DESIGN ADVISORY BOARD Tuesday September 24th, 2019 at 3:00 PM Conference Room 12, City Hall, Burlington, VT

TO: Design Advisory Board
FROM: Scott Gustin
DATE: September 24, 2019
RE: 20-0249CA; 3173 North Avenue

Request: Demolish existing home and replace with new home on existing footprint.

Parking location and building orientation are in need of revision. Continued review is recommended if not addressed prior to DAB review on the 24th. If satisfactorily addressed, then a recommendation of approval with the following conditions is advised:

NORTHWEST VIEW

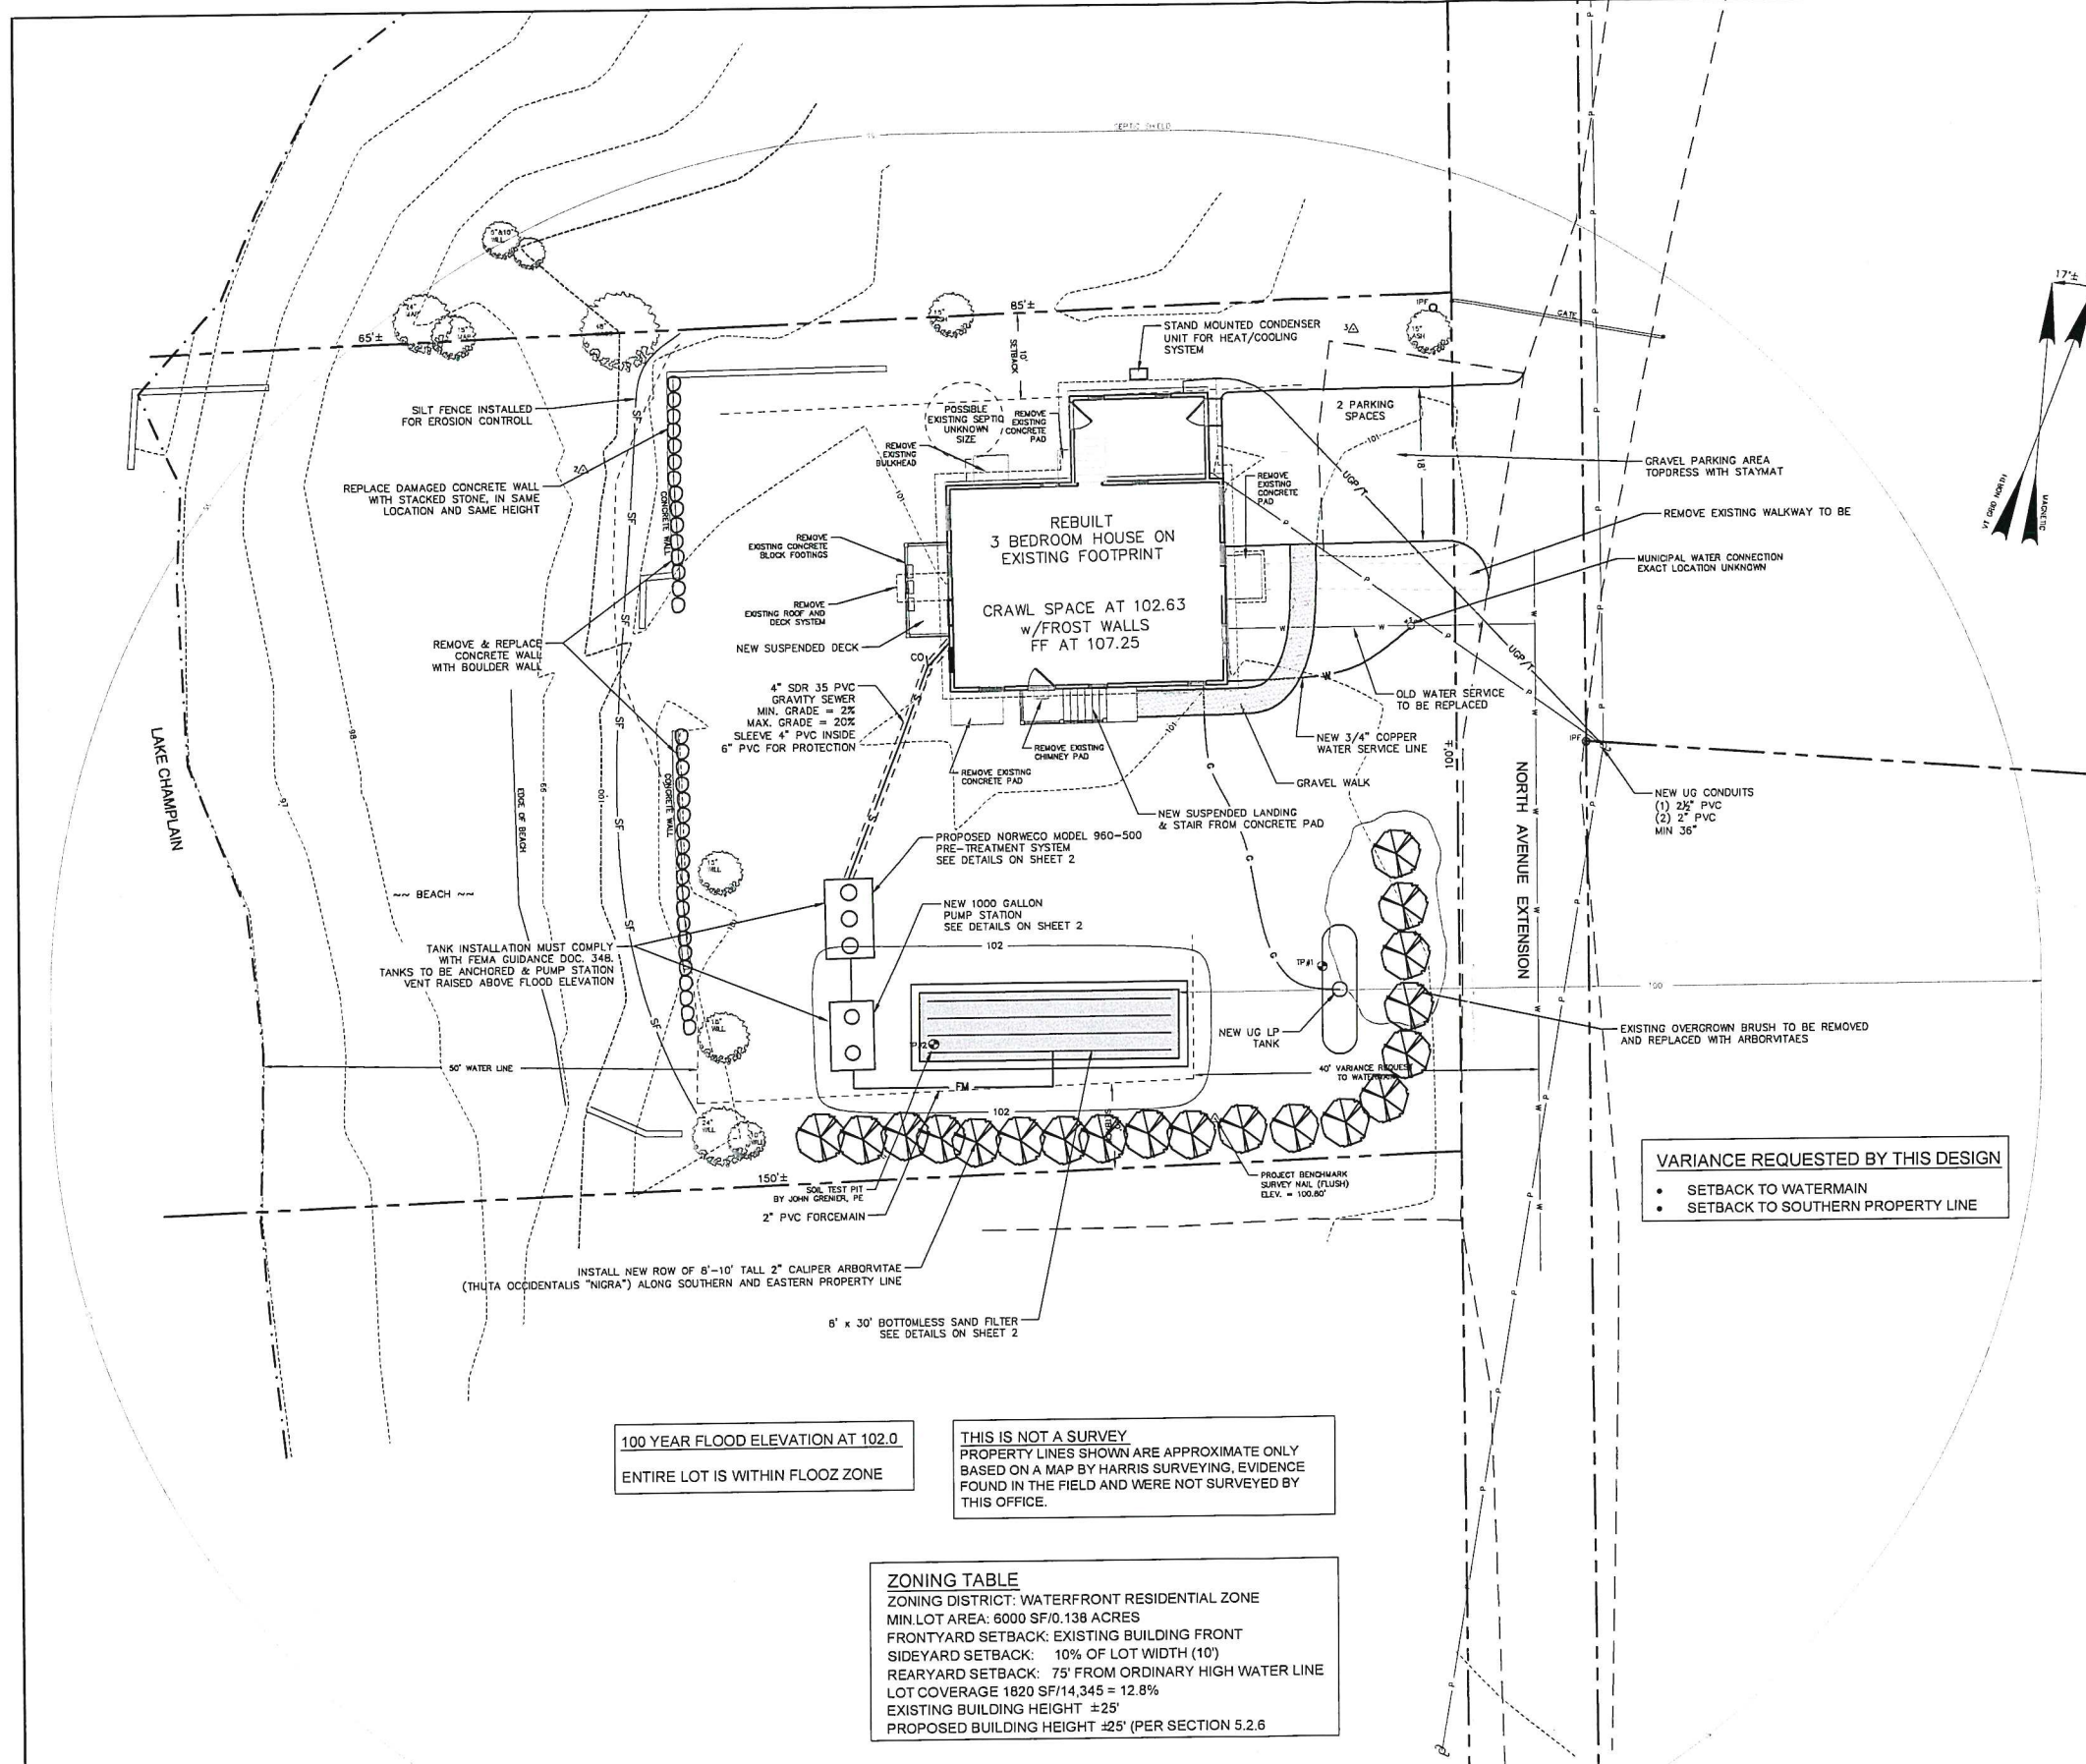
As proposed, the new home appears to face south, parallel to the street rather than to face it. The proposed home could simply be rotated to face the street, or the proposed east elevation could be revised with at least an enhanced entryway as noted in Sec. 6.2.2 (h). Other than the building orientation, exterior building features such as windows, differing materials, and roof overhangs provide visual interest to the structure and are acceptable. Large blank walls are avoided.

1. Revise the front door to look more like an entry door (match that on the south elevation).
2. Move the parking as far south as possible to be located to the side or rear of the house.

Site Plan
15/19 Conger Ave., Burlington, VT

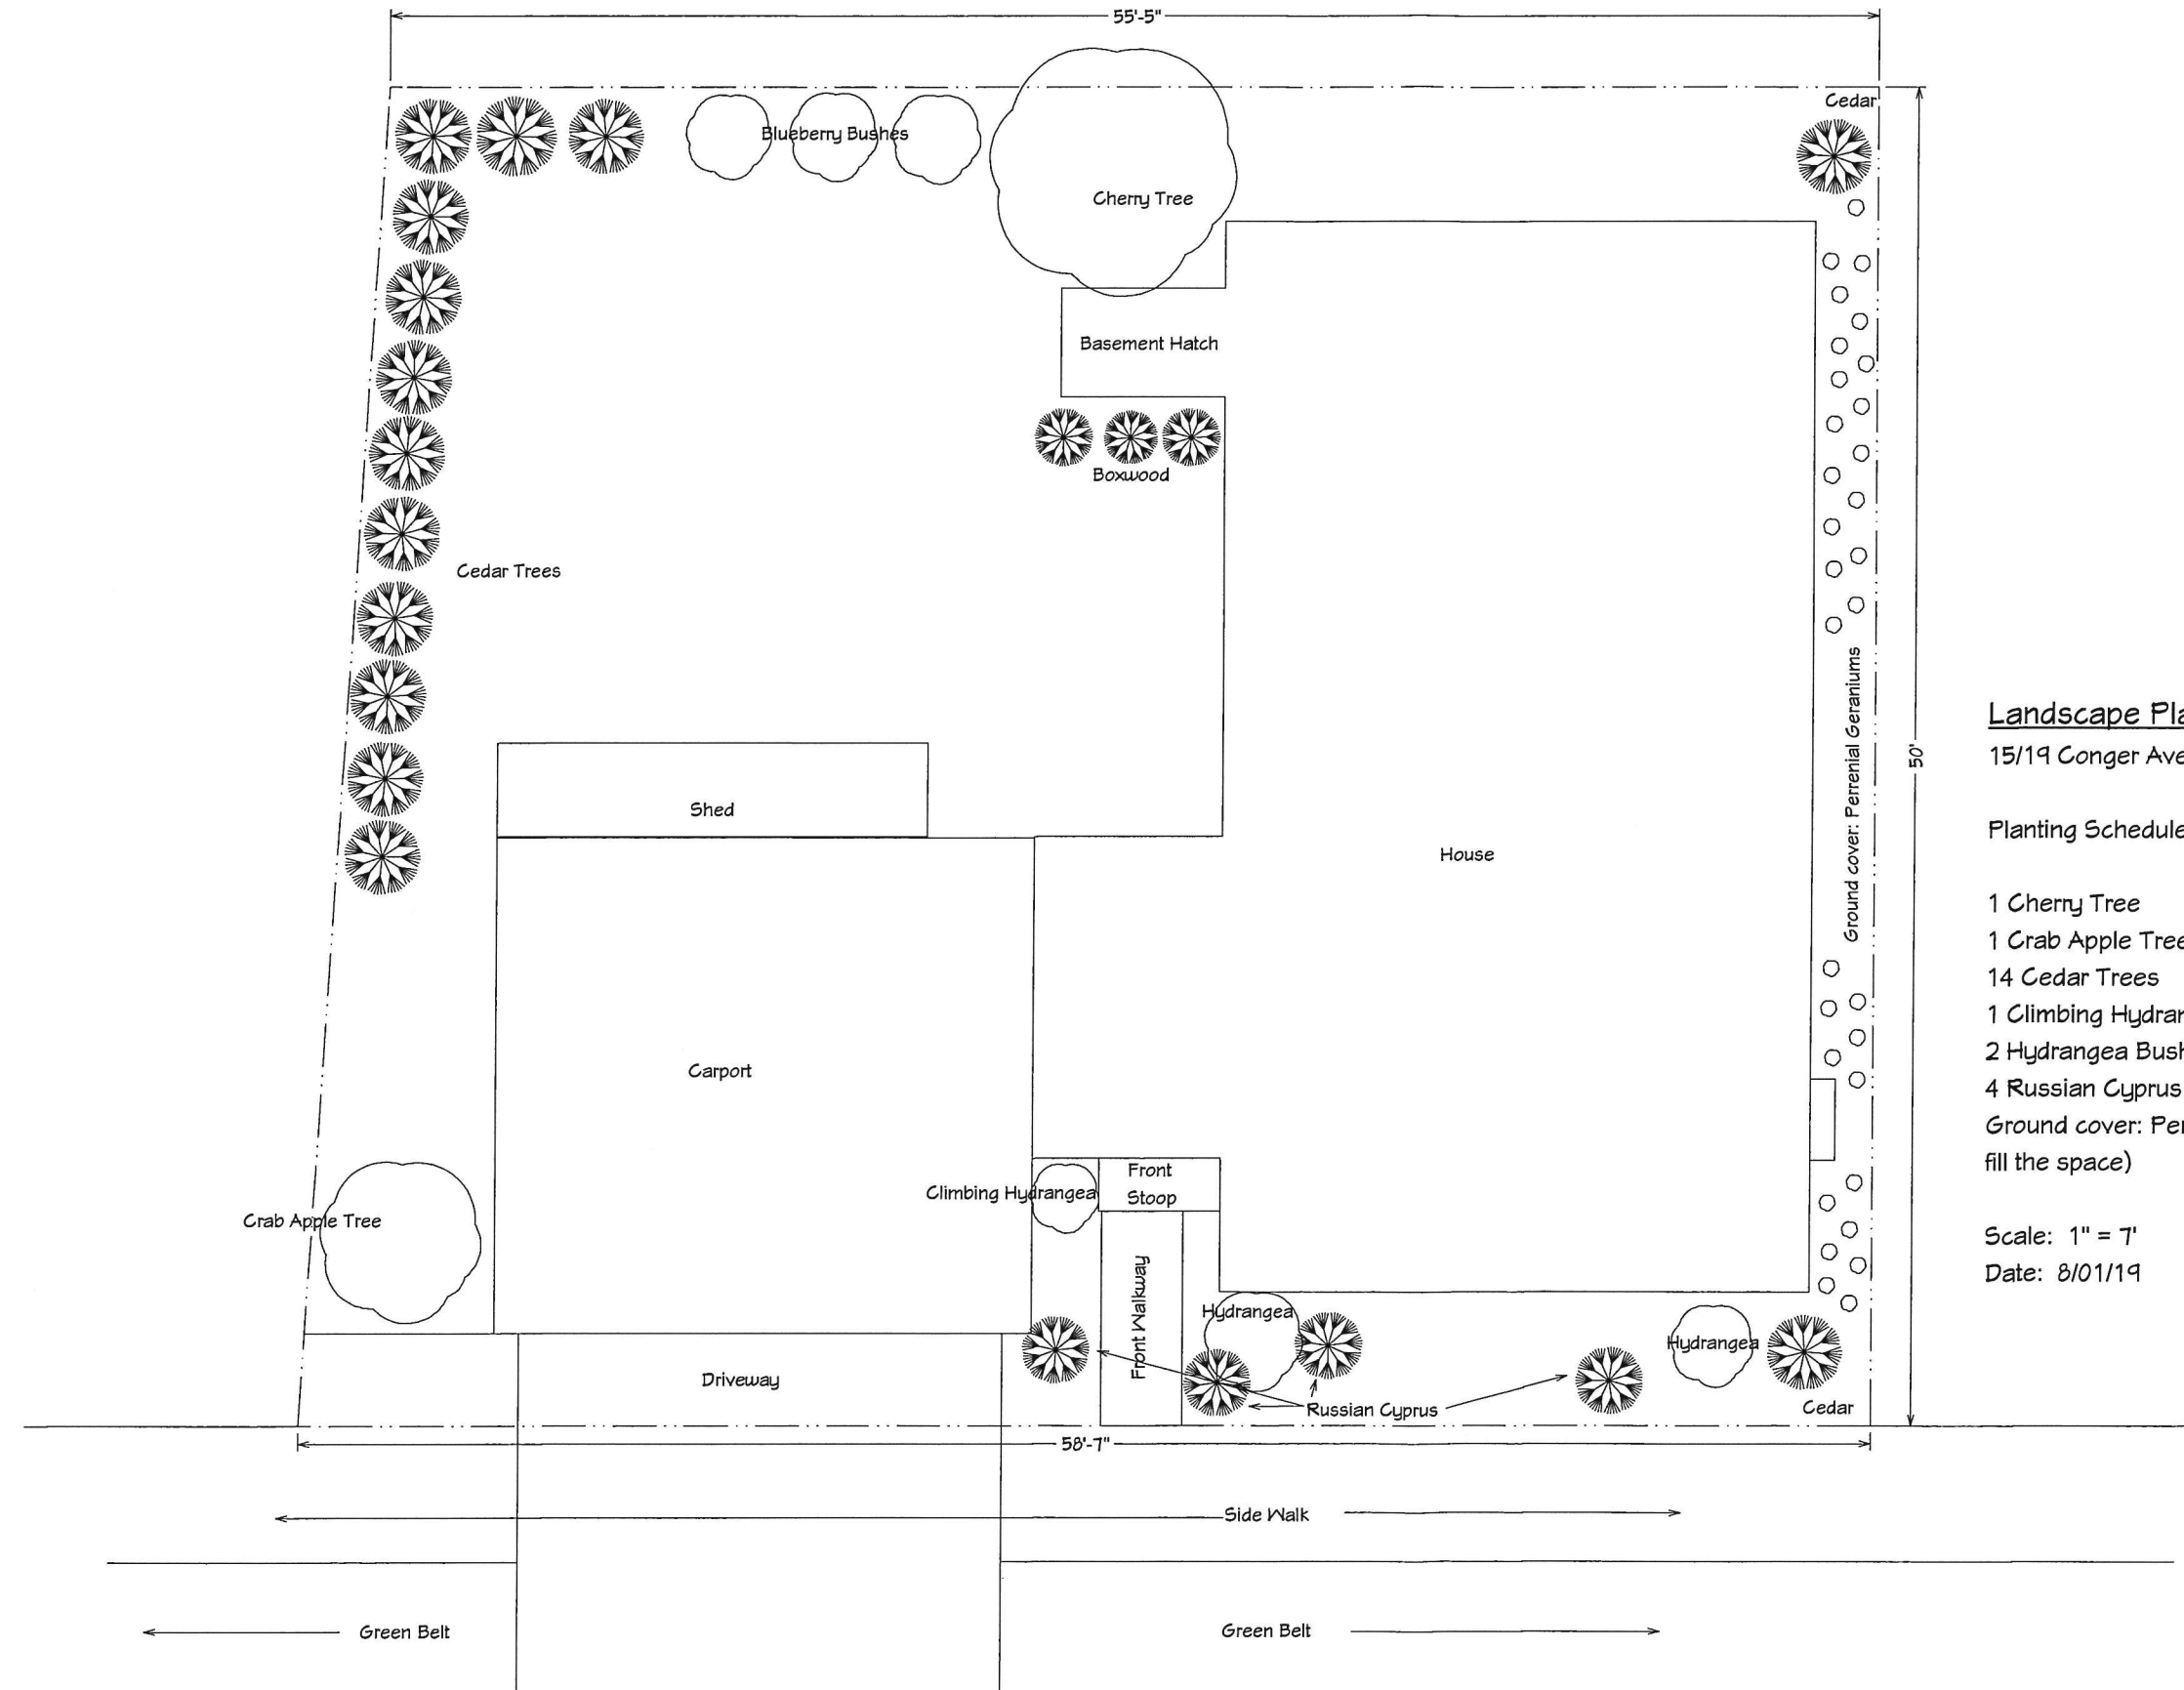
The placement of the attached carport is problematic. This criterion states that garages with street-facing doors must be set back behind the front plane of the home. It goes on to further specify a minimum 25' front yard setback for street-facing garages. The new carport has no doors but is oriented towards the street. The intent of this criterion continues to apply. Given the existing 11' setback nonconformity of the existing street-facing garage, the new attached carport could retain this 11' setback. It cannot; however, be set closer to the street than the existing setback. Retention of this nonconformity would still result in a greater setback than that for the living quarters and could be acceptable. Revision is needed.

A 2-car carport will provide space for the required off-street parking associated with the single family home. It will be accessed by a short driveway. Revisions to the placement of the carport and to the driveway are needed as noted above.

2. The Board accepts location of the carport with an 8 ft. front yard setback, as the carport is not a garage. It contains no doors and is recessed from the front plane of the house.

Landscape Plan

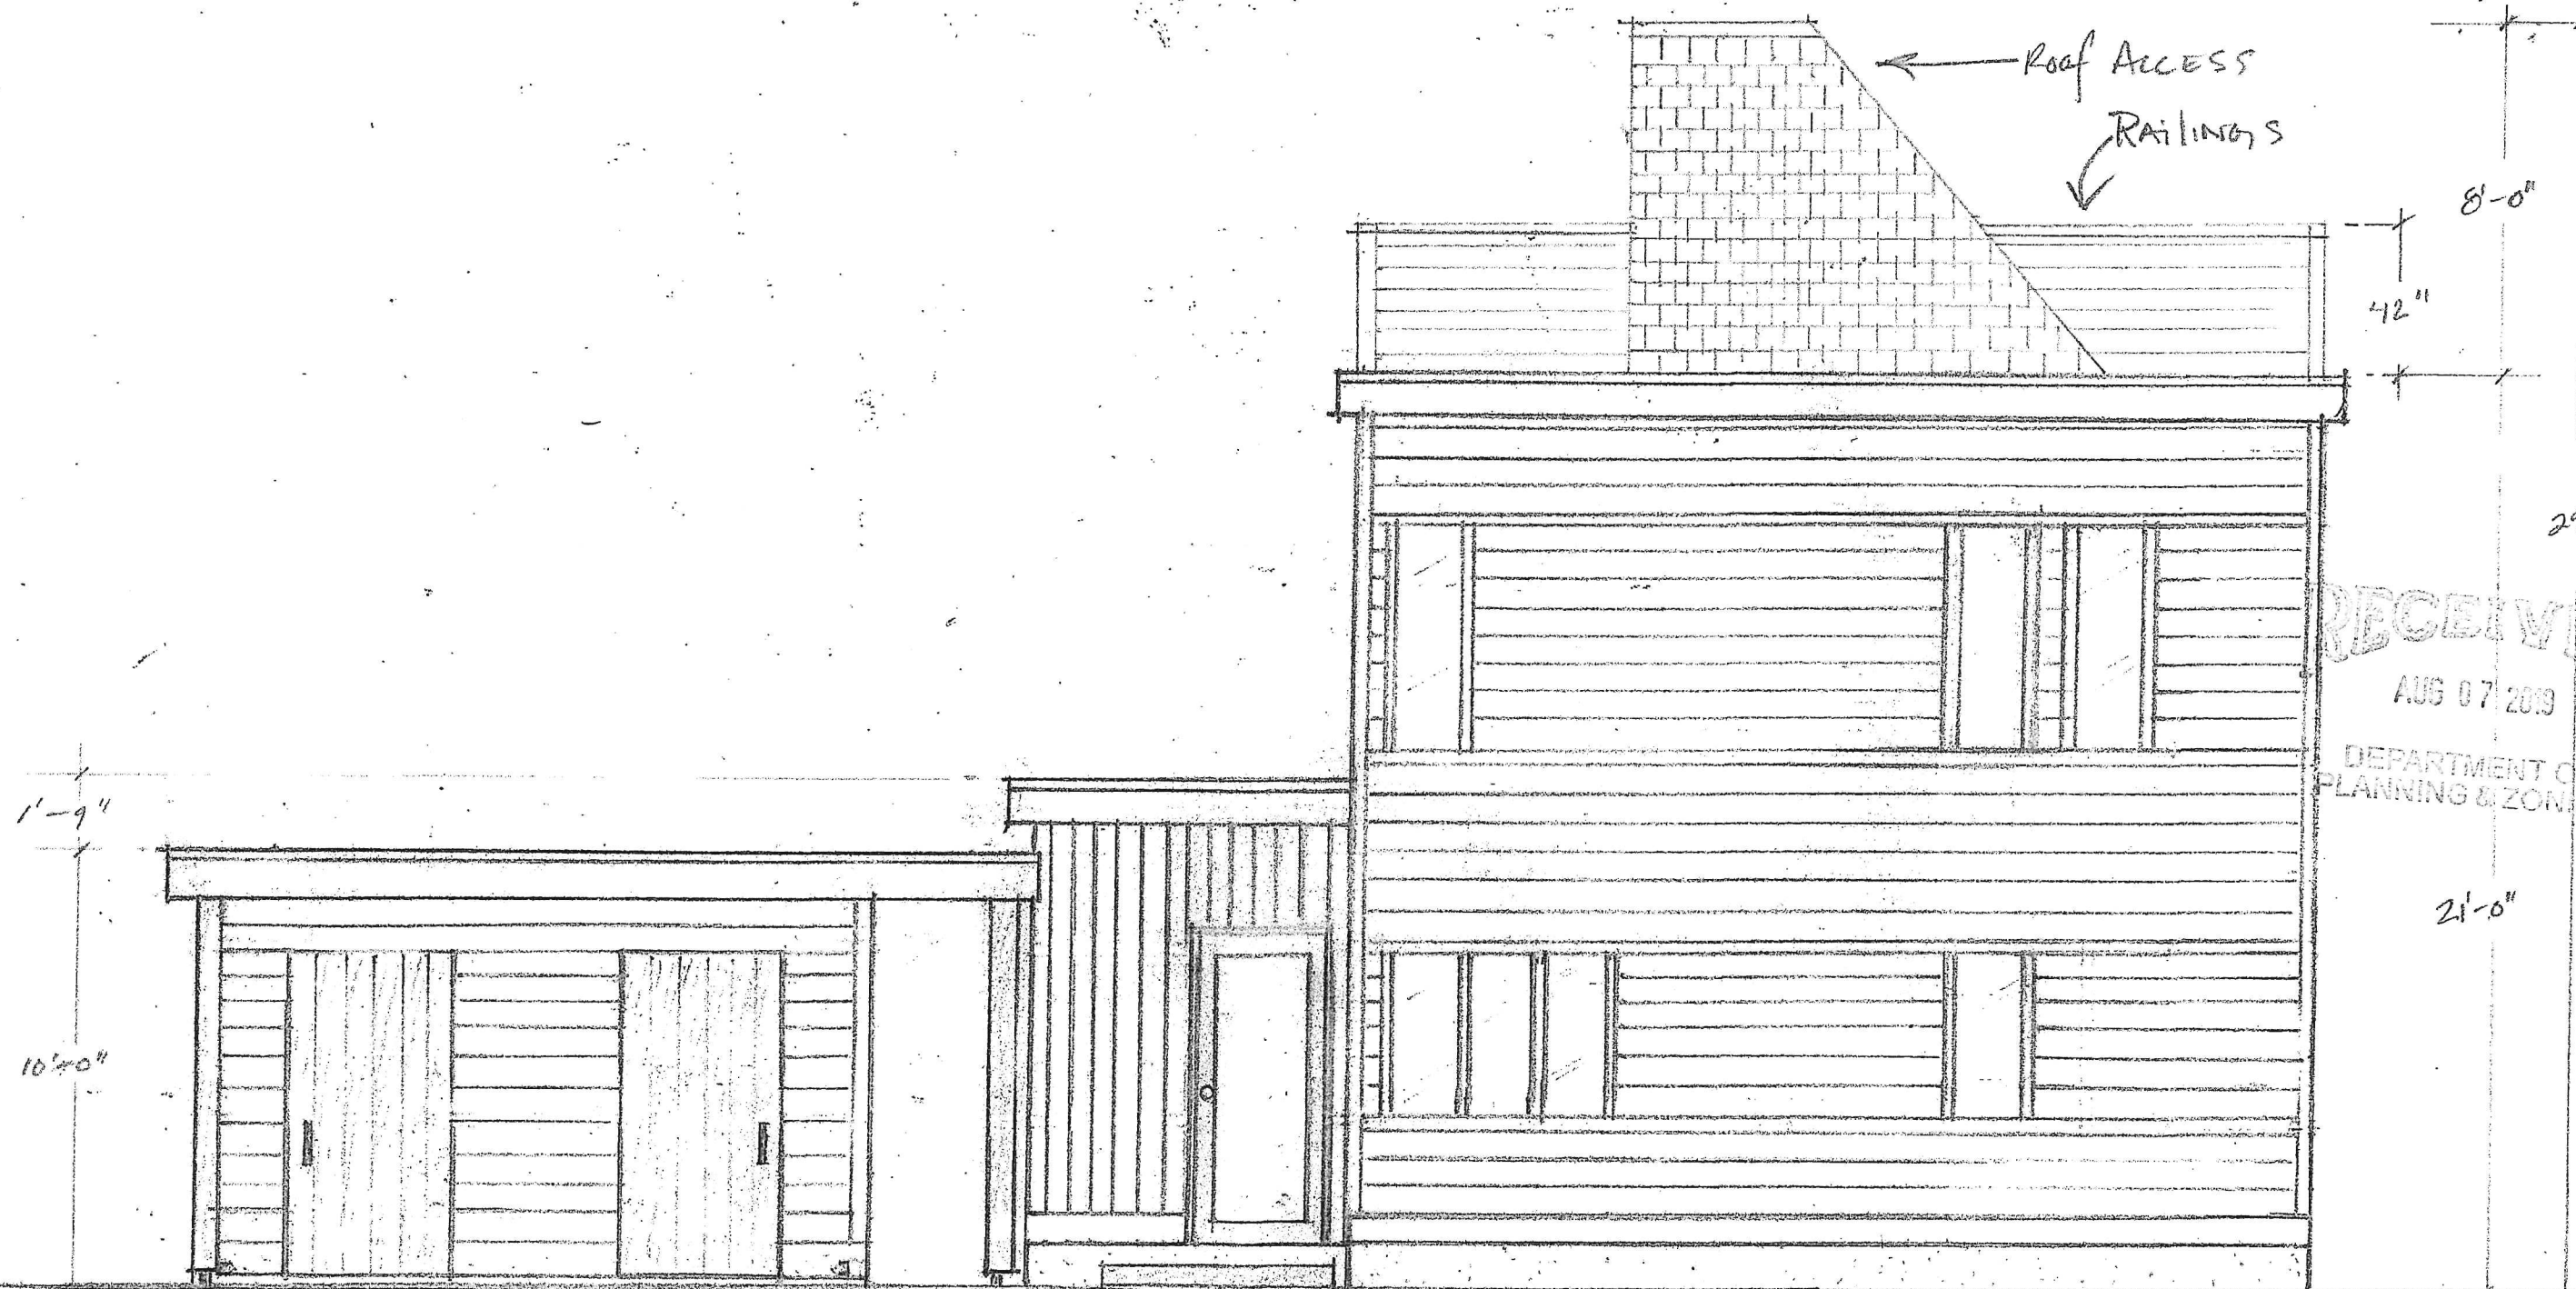
This criterion requires that a walkway be provided between the building's primary entrance and the public sidewalk. The landscape plan depicts a walkway out to the sidewalk; however, material is not noted and must be.

A landscaping plan has been provided and depicts species and placement. New plantings will be installed to define the property boundaries and to accentuate the street-facing façade of the home. While basic, the proposed landscaping plan is acceptable for this new single family dwelling.
